SUBJECT: BROWN'S FERRY NUCLEAR PLANT - NSRS REVIEW REPORT NO. R-80-12-BFN

TENNESSEE VALLEY AUTHORITY
NUCLEAR SAFETY REVIEW STAFF
REVIEW
NSRS REPORT NO. R-80-12-BFN

SUBJECT: BROWNS FERRY NUCLEAR PLANT UNITS 1, 2, AND 3 - CONTROL ROD DRIVE SYSTEM MALFUNCTIONS AT UNITS 1 AND 3 - NUCLEAR SAFETY REVIEW STAFF REVIEW REPORT NO. R-80-13-BFN

FIGURE 1- CONTROL ROD DRIVE SYSTEM (Not to Scale)

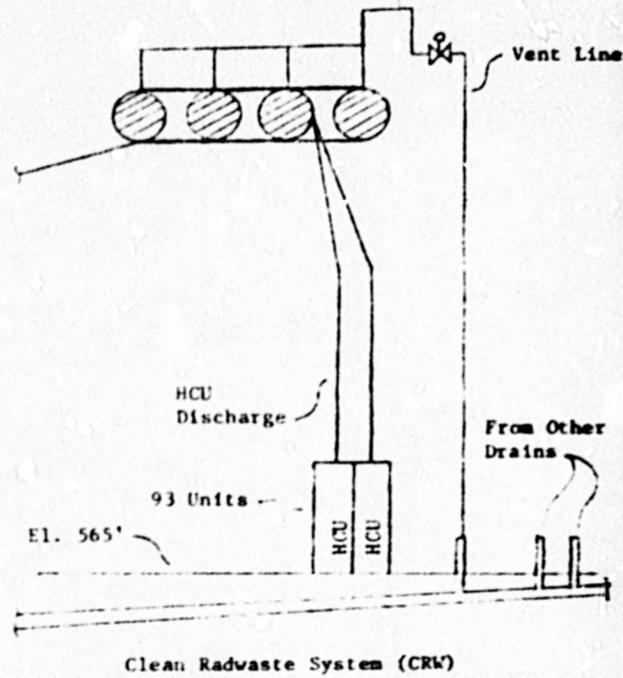
On July 25, 1980, an exit meeting was conducted by the NSRS representatives with those persons indicated in paragraph VI to summarize the purpose, scope, and findings of the special review. Except as noted below, the following findings were discussed and acknowledged by plant personnel as preliminary conclusions and recommendations at that time. NSRS' recommended modifications will provide corrective action to eliminate identified possible fundamental deficiencies in the present scram discharge headers (SDH)/scram discharge instrument volume (SDIV) arrangements. Figures 1 and 2 illustrate original and recommended configurations, respectively.

The CRW system exerts a complicated influence on the 6-inch SDH/SDIV subsystem as they function to accumulate and discharge water received from a unit scram. In the present configuration, the vents and drain for the subsystem are piped to the CRW system, which is closed except for its submerged discharge, and the "positive vents" added per IE Bulletin No. 80-17. A considerable and most important portion of the scram discharge volume subsystem is composed of each 6-inch SDH volume and its 2-inch drain line to the SDIV. In all three BFN units, the east-side SDH's and their drains have a very gradual slope and extensive, constricted length of flow path, which results in a lengthy drainage time (20-30 minutes) under the most favorable of conditions. The information that a quantity of water may reside in a horizontal portion of SDH/SDIV vent or drain line (see section A above) and that differential pressures can exist between local points in the same CRW header (BFN-1 incident of July 19) gives rise to a serious concern regarding the need to disconnect the CRW system altogether from the scram discharge portions of the CRD system. For example, in case of a pressurized CRW system, as in unit 1, addition of a positive vent to the SDH does not remove the possibility of some form of liquid lock on the SDIV drain line. Also, the failure of a non-redundant SDH vent valve, as occurred at Dresden unit 3, could result in accumulation of water in the SDH piping.

FIGURE 2 - MODIFIED CONTROL ROD DRIVE SYSTEM (NOT TO SCALE)

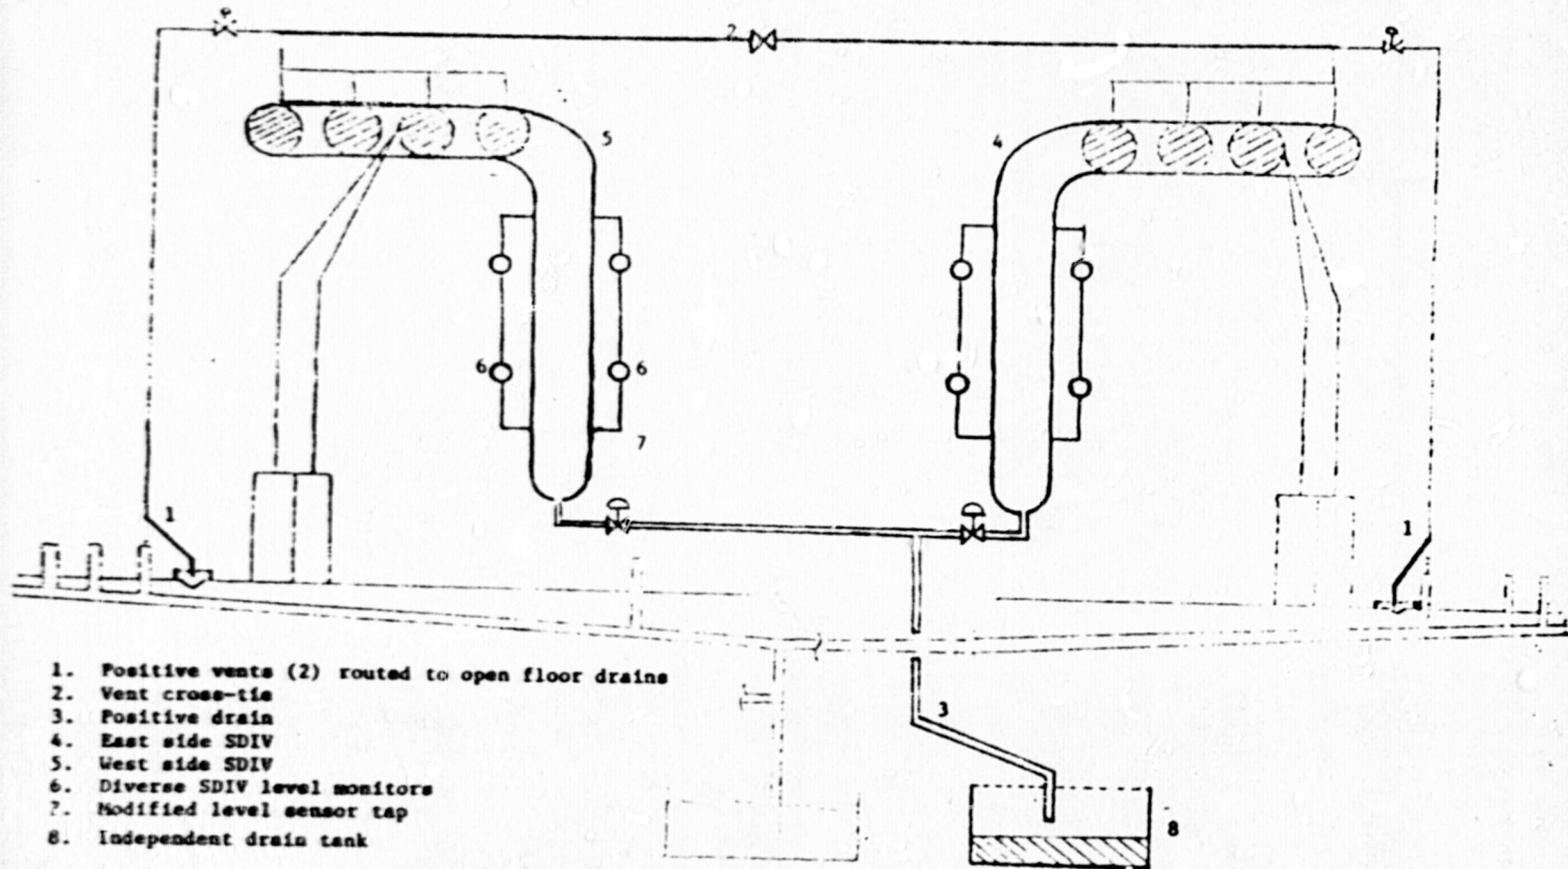
NSRS recommends the following modifications to the vent/drain portions of the scum discharge volume (see figure 2):

Modifications should be made to the control rod system such that drainage from the 6-inch SDM into the SDIV is assured regardless of a functional vent path. Two modifications are essential to accomplish this (see figure 2):

1. Disconnect each SDW vent line from the CRW system and provide a positive vent to atmosphere.
2. Cross-connect the SDW vent lines inboard of the vent valves.
3. Provide an atmospheric sump tank for collection of SDIV drains.
4. Disconnect the SDIV drain from the CRW system and provide a positive drain path (downstream of the drain valve) to the atmospheric sump tank.

1. An extension should be added to the east side SDM end. The extension would turn downward to form a new east side SDIV. The new tank drain line would be configured as described in item D.
2. The existing SDIV should be modified to be identical to the new east side SDIV.

Besides ensuring scram discharge volume drainage independent of a functional vent path, these modifications will increase the capacity to handle and detect leakages into the SDM and decrease the post-scram drain time. These modifications should be accomplished in the time frame specified in item D.
